GNRO-2011/00053

SUBJECT: Request for Additional Information Regarding
Extended Power Uprate
Grand Gulf Nuclear Station, Unit 1
Docket No. 50-416
License No. NPF-29

Grand Gulf Nuclear Station Extended Power Uprate

Mechanical and Civil Engineering Branch, Steam Dryer (Non-Proprietary)

Figure 2-2: GGNS SRV Branch Line Configuration

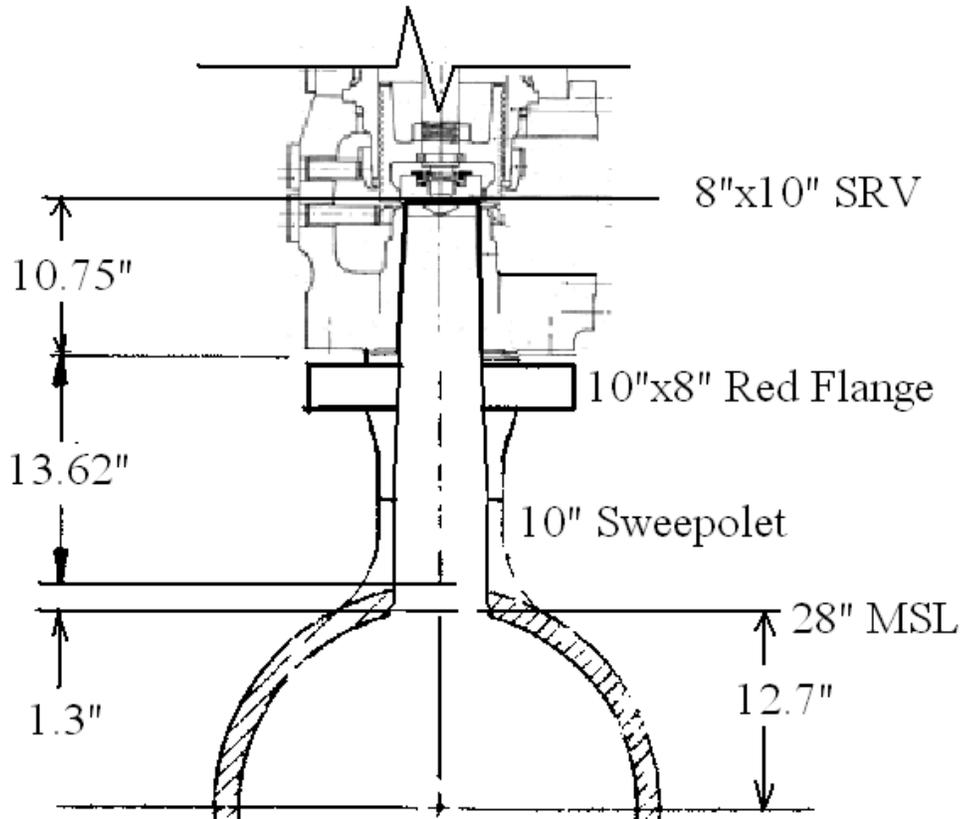
In response to RAI 9, the licensee stated that four safety relief valves (SRVs) will be instrumented and monitored to maintain acceleration levels within the acceptance limits. Please explain how the licensee will ensure that the valve with the maximum vibration level will be among those that are selected for vibration monitoring. Also, please provide the plan for mitigating excessive vibration (should it occur) and/or replacing valves with designs that are more resistant to the vibrations.

Another alternative would be to shorten the SRV branch connection and thus increase the branch fundamental acoustic resonance frequency. This would result in the Strouhal number $((\text{branch frequency}) \times (\text{branch diameter}) / (\text{MSL velocity}))$ at EPU being equal to or higher than the Strouhal number at CLTP where excessive valve vibration has not been observed. The steam line velocity at CLTP is approximately [[]]

]] (See EPU LAR, Attachment 11, Appendix A). Figure 2-2 depicts the existing GGNS SRV branch geometry. It would be possible to replace the reducing flange with a design that would reduce the branch length by approximately 3.5 inches and increase the branch line resonance enough to offset the increase in velocity.

Figure 4-1 Schematics of a Vane Assembly

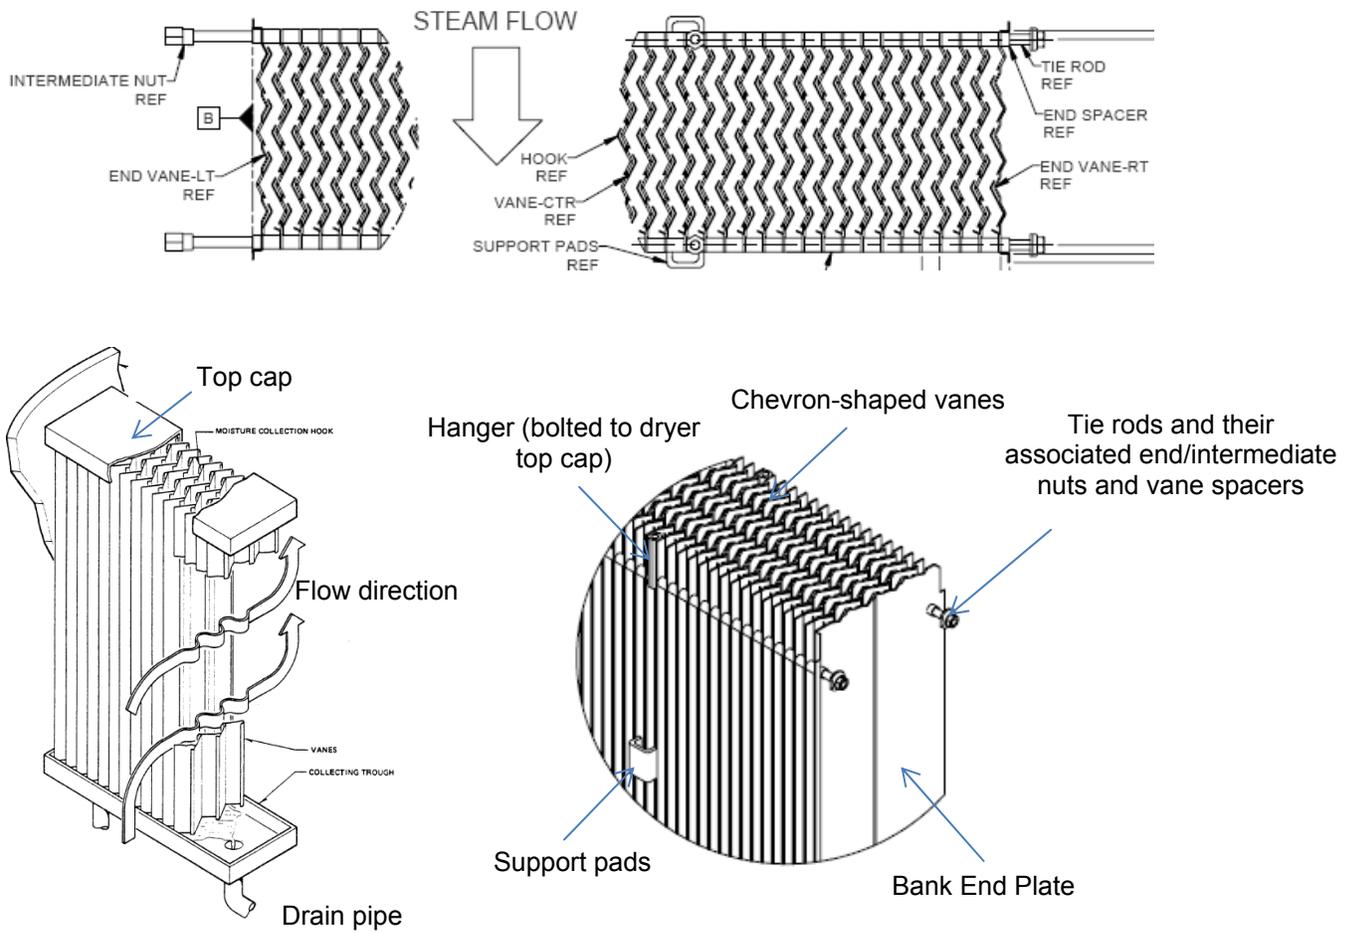
]] Also, please explain whether the vane assemblies can experience fatigue failure due to FIV loading and generate loose parts. Please provide information on the magnitude of the fundamental frequency of the vane assembly substructure.

- a) The purpose of the chevron-shaped dryer vanes is to remove the moisture from steam. The vane assemblies are housed within the dryer hoods. They are contained within the bank end plates, the top cap, the bank trough, and the inlet and outlet perforated plates. The individual tie rod sections holding the vane plates and spacers in place are 4½ - 5 feet long and joined together with intermediate fittings to form continuous rods that run the entire length of the dryer bank. The tie rod end nuts are then welded to the bank end plates, capturing the tie rods, vane plates, and spacers. The chevron-shaped vanes and their associated tie rods are shown in Figure 4-1. [[

]] The “stacked plate” assembly of the vanes and spacers on the tie rods rest in the bank trough. This configuration has a large number of [[
